Comment (Page 170, Line 10, Clause 145.2.10)

This comment is marked UNB\_REQ.

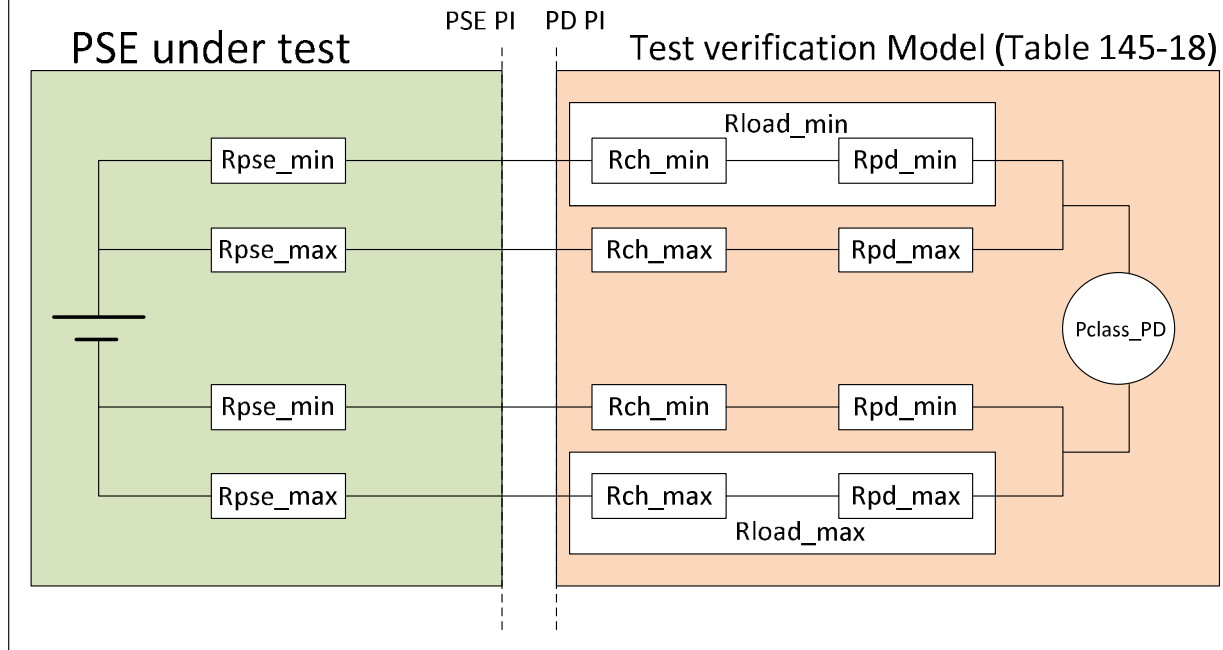
As a result, when connecting the PSE to the test verification model, we will fail lunbalance-2P in Class 5,6 and 7 and 8. The reason for the failure:

Eq-1: Icon-2P\_unb=sim\_results + 5mA.

Eq-2: lunbalance-2P = Icon-2P\_unb -10mA = sim\_results + 5mA -10mA =sim\_results -5mA

→ Actual sim results < lunbalance\_2P spec value → failing the test. The worst-case SIM result is the minimum spec value for lunbalance-2P. (and to add to the other margin in the next tables.

## 4-Pair model used to derive the spec numbers

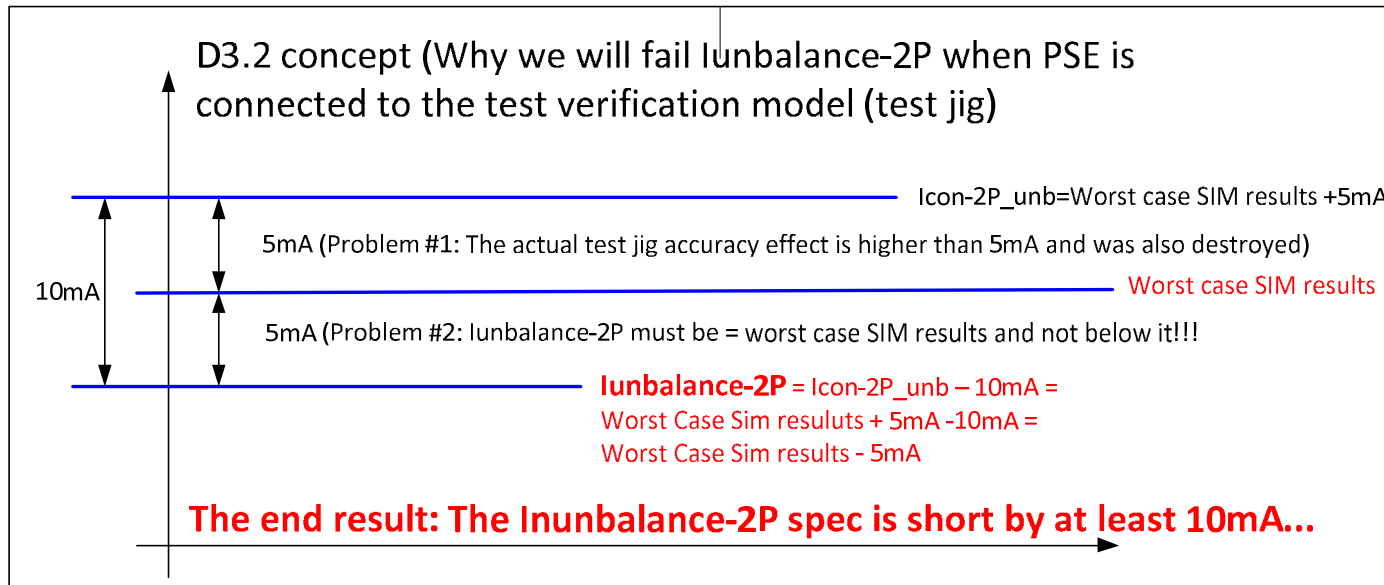
- The above is our 4-pair model used to derive the PSE and PD equations and  $I_{max}$  at worst case unbalance conditions.
- It is impossible that if the sim results for class 5  $I_{max}=0.5493A$  we will pass the  $I_{unbalance-2P}$  test  $=0.455A!$
- We must pass the test for all PSE operating range from 50V to 52V.
- The same problem for all classes.
- For Extended power class 8:
  - The test verification model values of  $R_{pd\_min}/max$  (which is  $R_{load2\_min}$ ,  $R_{load2\_max}$  in Table 145–18) are not valid for this case.
  - Equation 145-26 is not valid. Tighter  $R_{pd\_max}/R_{pd\_min}$  ratio is required.

The correct approach is:

1.  $\text{lunbalance-2P} = \text{Worst case sim results} + \text{Margins due to test jig component accuracy.}$
  2.  $I_{con-2P\_unb} = \text{lunbalance-2P} + 10\text{mA}$
- The margins topic needs a discussion to conclude if we need it and how much we need from it

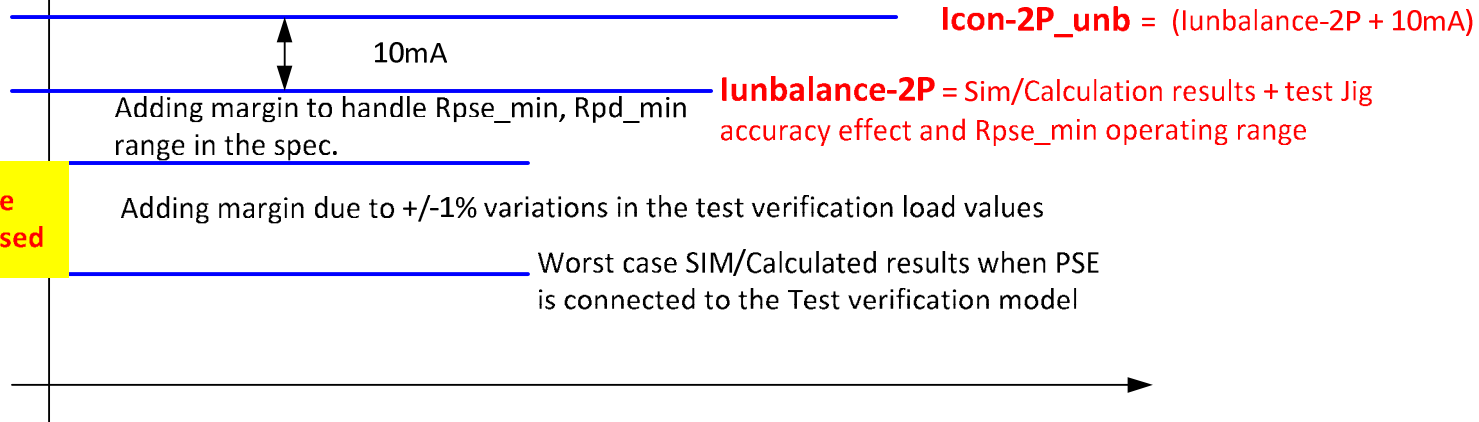
Propose concept to fix the problem based on actual physics..
